FAIRFAX COUNTY

STAFF REPORT

APPLICATIONS PCA 86-W-001-7/FDPA 86-W-001-5
and PCA 86-P-089-4/ FDPA 86-P-089

PROPOSAL: Amend Proffers, Conceptual Development Plan and Final Development Plan for Land Bay A of the Government Center to redesign the regional stormwater management system and to permit other site modifications.

LAND BAY

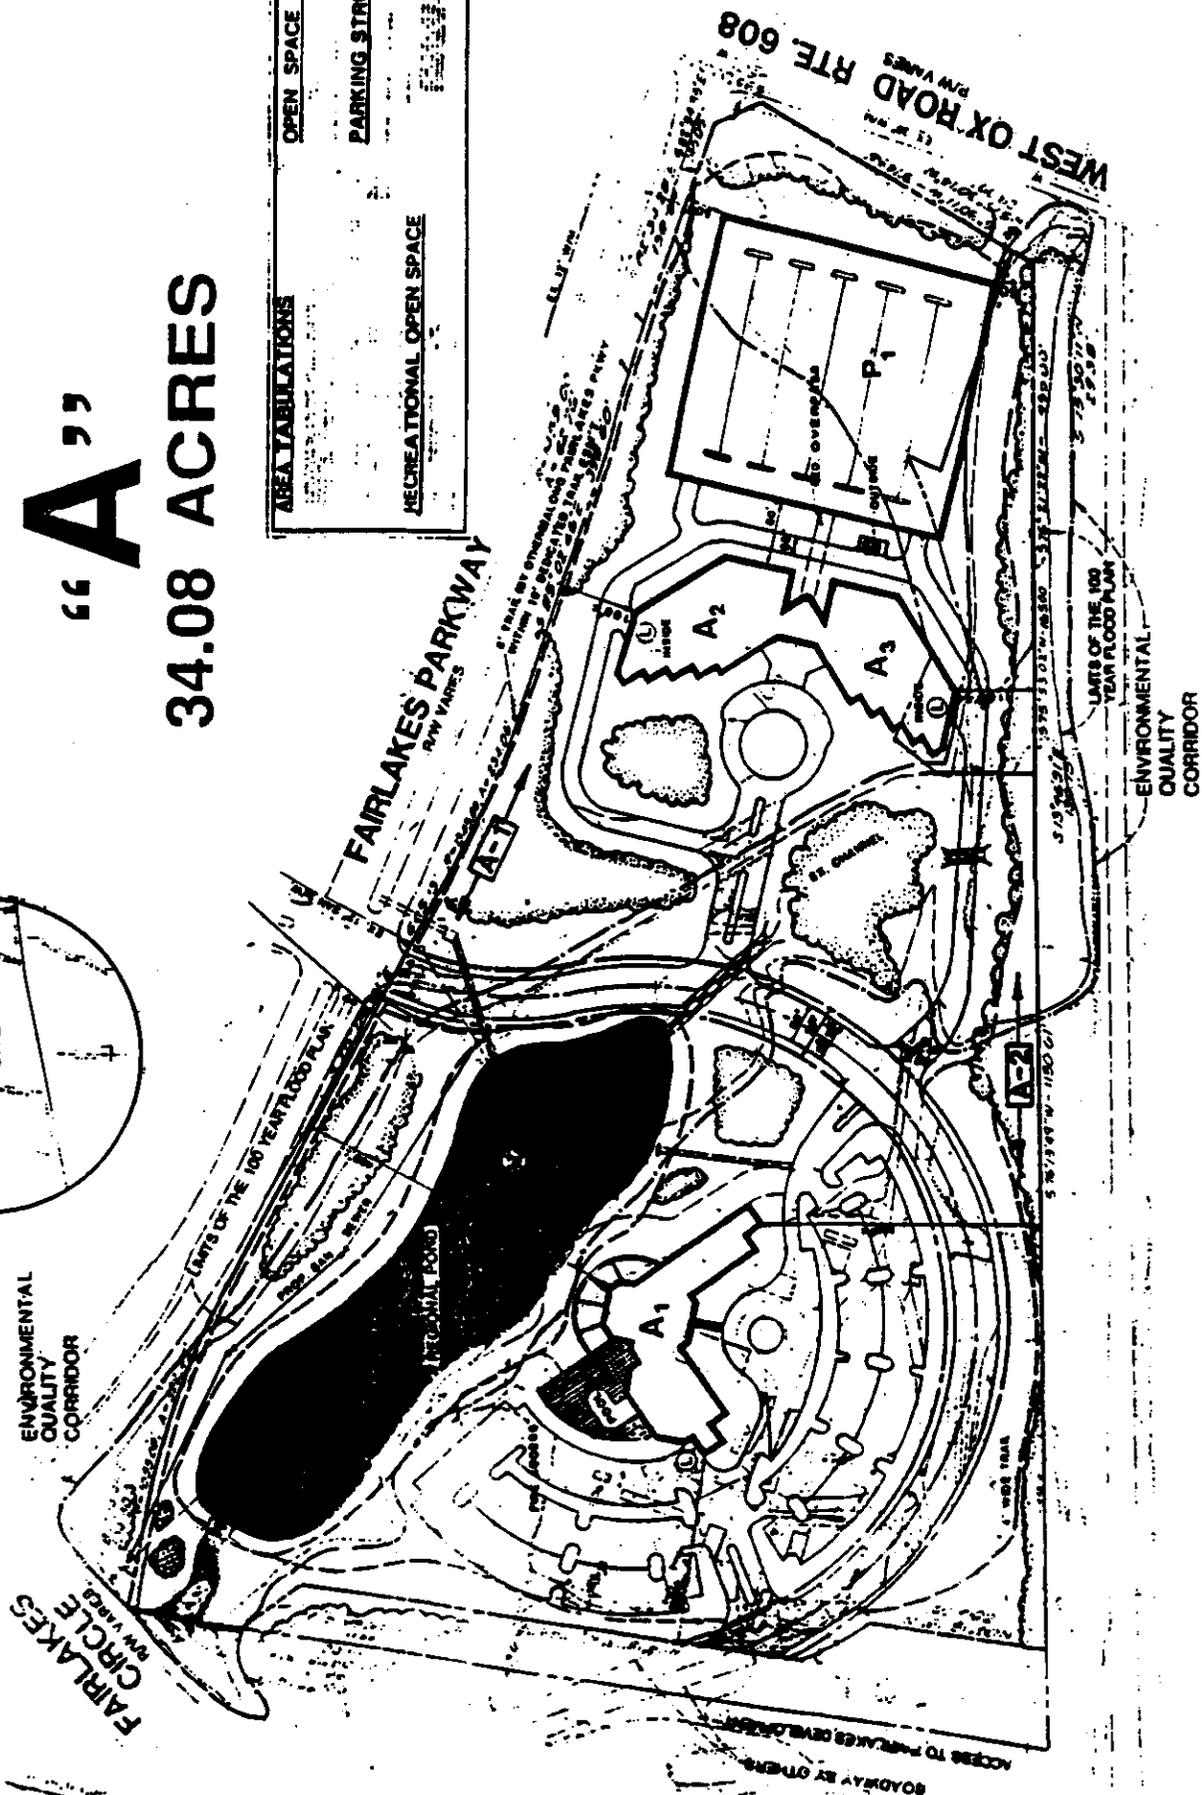
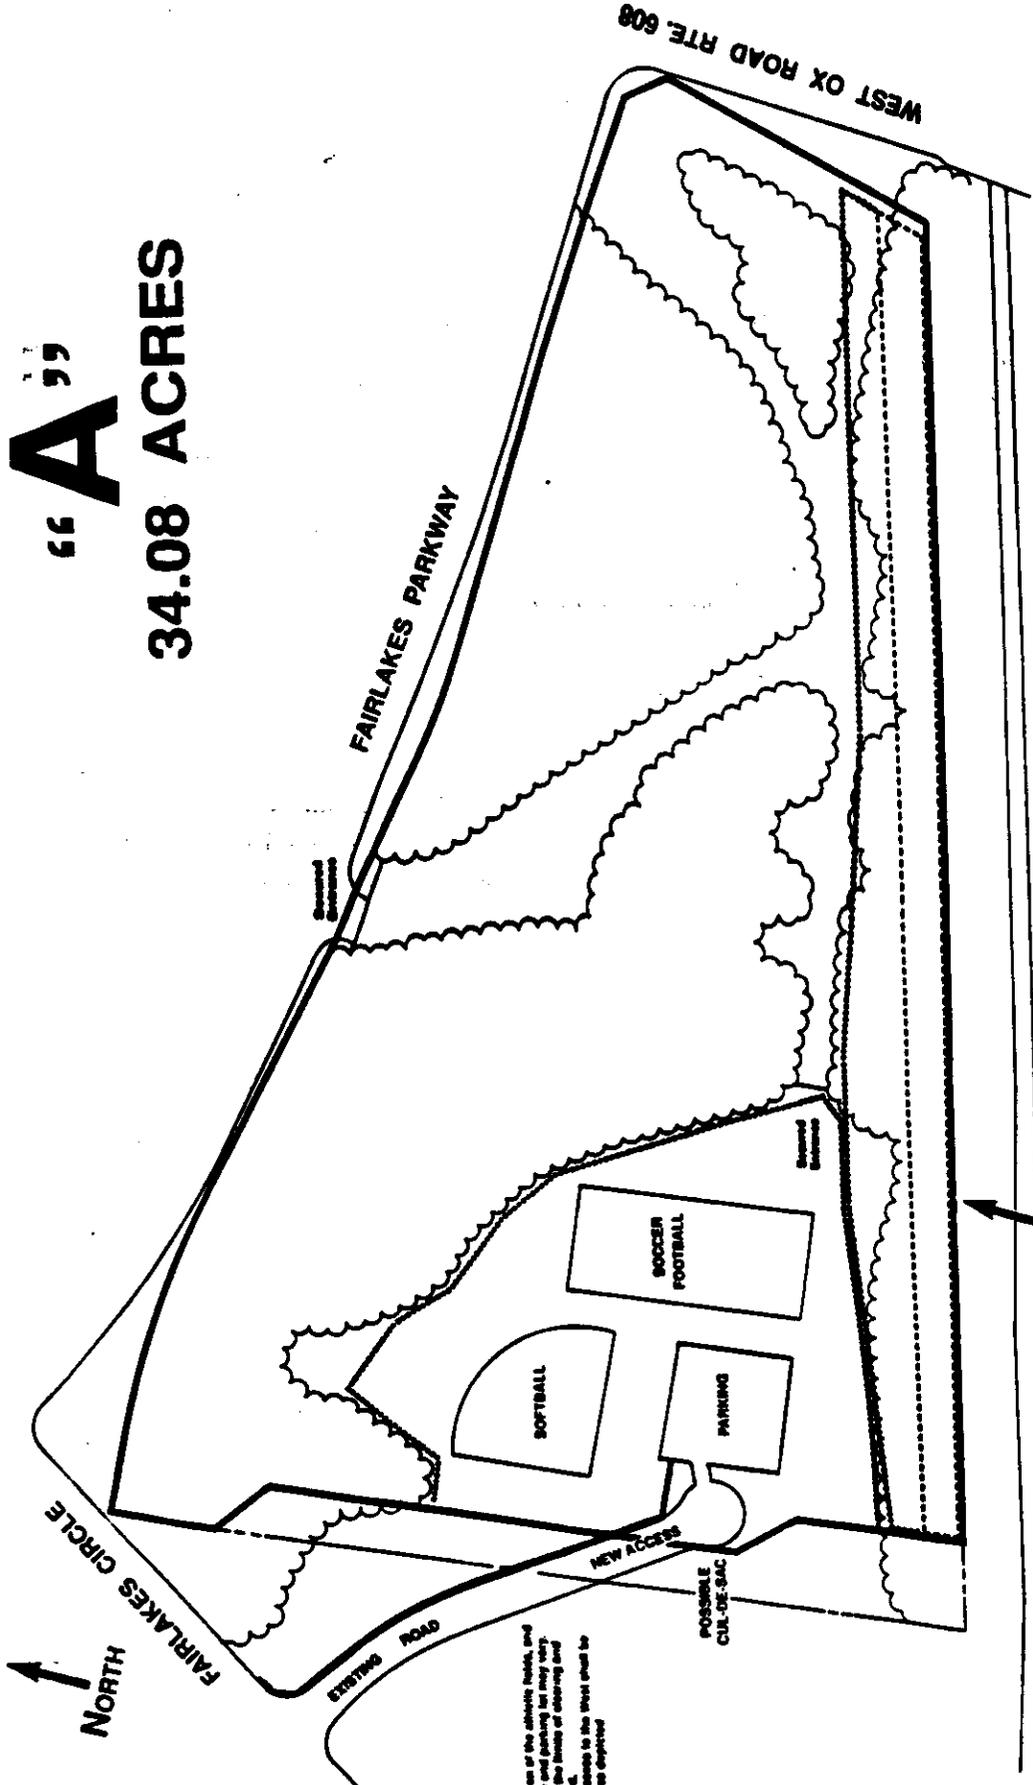
1. Interim development of the subject property as temporary athletic fields (Phase 1) shall be in substantial conformance with Sheet 1 of the CDPA/FDPA entitled "Land Bay A", dated August 1995 and revised through September 1995.

2. Phase 2 development (office/hotel option) shall be in substantial conformance with Sheet 2 of the CDPA/FDPA entitled "Land Bay A", dated August 1995 and revised through September 1995 and Attachments 1 through 10.

3. Prior to the construction of any temporary athletic fields on Land Bay A, the following conditions shall be met:
 - a) The limits of clearing and grading shall be provided as depicted on Sheet 1 as determined by DEM. The number, type and location of athletic fields and the exact location of the driveway and parking lot may vary from that depicted on the CDPA/FDPA, but the athletic fields, driveway and parking lot shall be located within the depicted limits of clearing and grading.

4. The necessary right-of-way and/or easements shall be provided for the widening of I-66 and/or the construction of the flyover as depicted on Sheet 1 of the CDPA/FDPA dated September 1995 at such time as design plans for the roadway are completed, or site plan approval for Phase 2 development occurs, whichever occurs first.

SUBJECT: Water Service Analysis, Rezoning Application PCA 86-W-001-7
FDPA 86-W-001-5

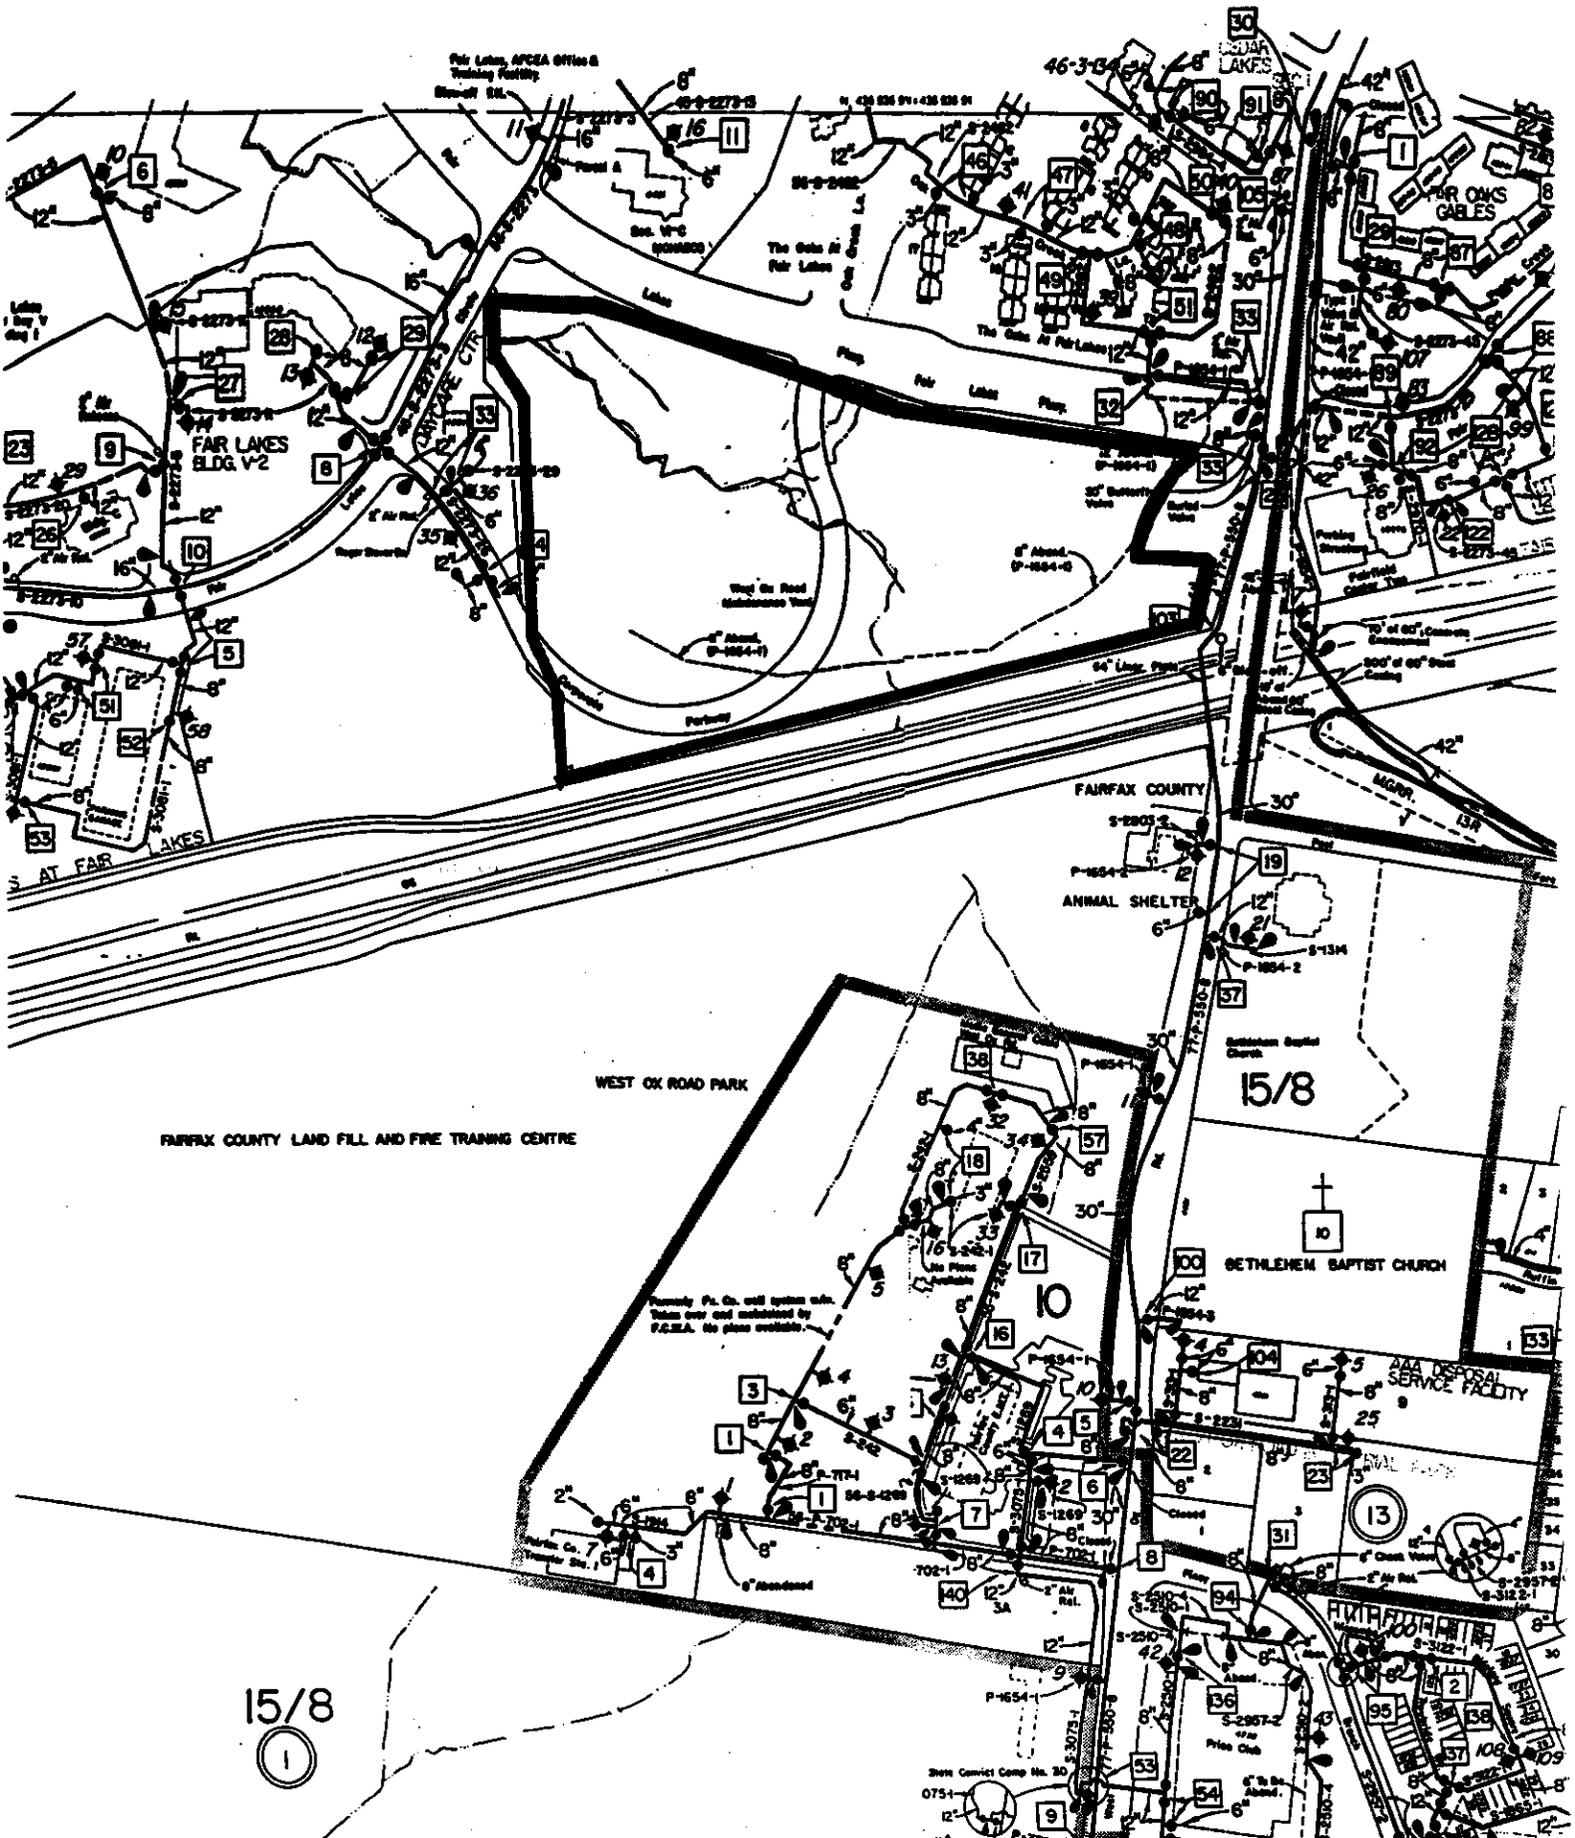
Adequate water service is not currently available at the site. An offsite water main extension is required for domestic service and fire protection. The nearest adequate water mains available to provide service are a 12-inch main located approximately 150 feet west and an 8-inch main approximately 150 feet east of the property.
